SERVICE BULLETIN

RA04-002f

2004-2010 ARMADA; CLICKING NOISE FROM REAR AXLES DURING TAKE-OFF / ACCELERATION

This bulletin has been amended. Changes have been made on all pages.
Please discard previous versions of this bulletin.

Figure 1

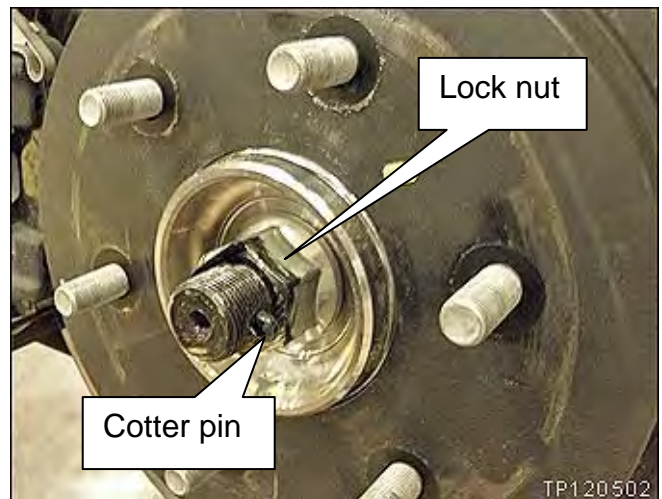
4. Remove the rear axle cotter pin.

Figure 6

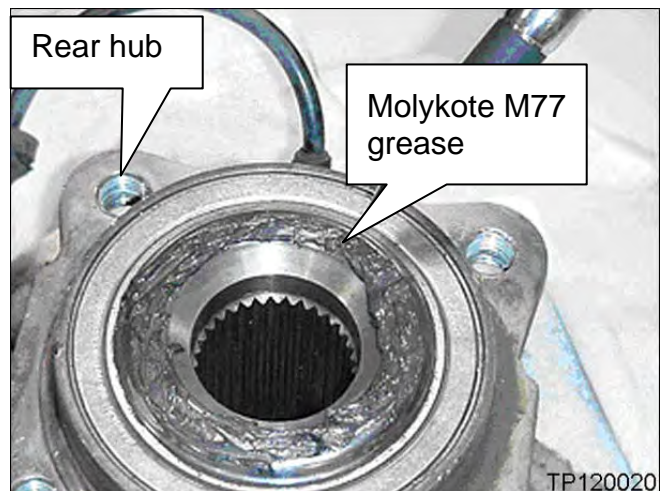
8. Apply a minimum of 1.0g of Molykote M77 Grease in an even coating to the bearing surface where it contacts the rear axle (see Figures 5 and 6).

- Use **only** Molykote M77 grease (P/N 44003-7S000). **Do not use any other grease.**

- Figure 6 shows the hub removed.
- This is done to provide a better view of the area where grease is to be applied.
- It is not necessary to remove the hub for grease application.

Figure 9

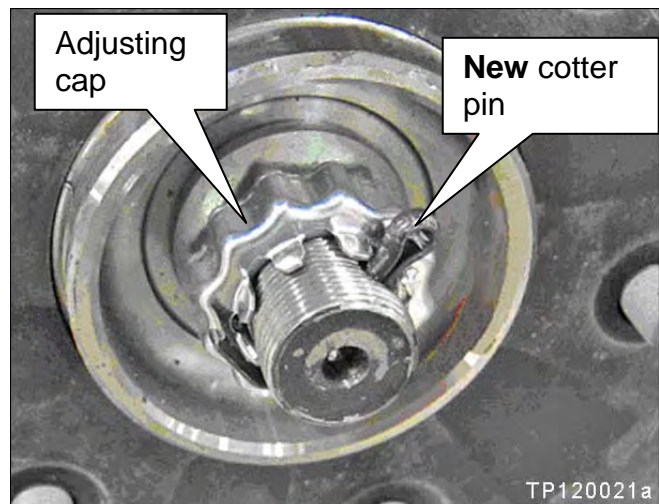
- The above torque specification is **new**. It is **lower** than the torque specification listed in the Service Manual.
- The new torque specification **must** be used in conjunction with the adjusting cap (see Figure 9).

11. Install an adjusting cap over the axle lock nut.

12. Install a **new** cotter pin.
